Sheet M3.2 SHOP BUILDING 1 - FLOOR PLAN - HVAC

PROJECT TITLE
GRANT COUNTY PUBLIC WORKS OFFICE/SHOP COMPLEX
EPHRATA, WA

SHEET TITLE
SHOP BUILDING 1 - FLOOR PLAN - HVAC

A1 | SHOP BUILDING 1 FLOOR PLAN - HVAC | 1/8"=1'-0"

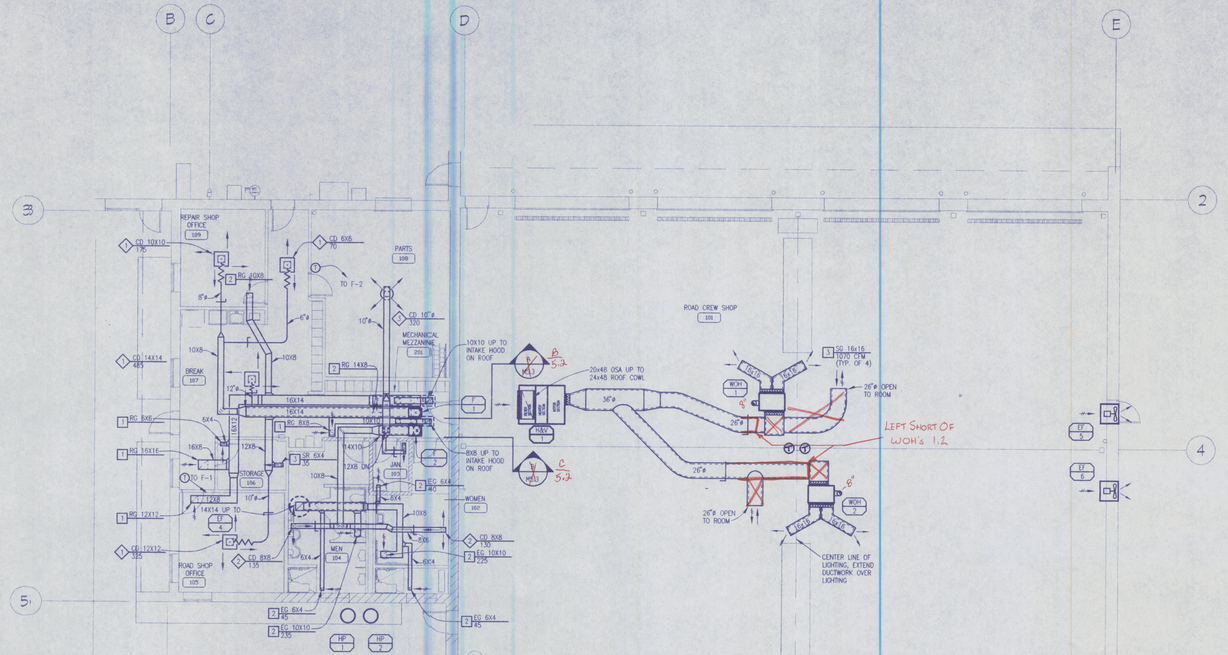
1. REVISE section callout A-5.3 to read B-5.2 and B-5.3 to read C-5.2. ADD #2, Page 4
2. ADD 8" dia. type L flue through roof with flashing and termination cap at waste oil heaters WOH#1 and WOH#2.
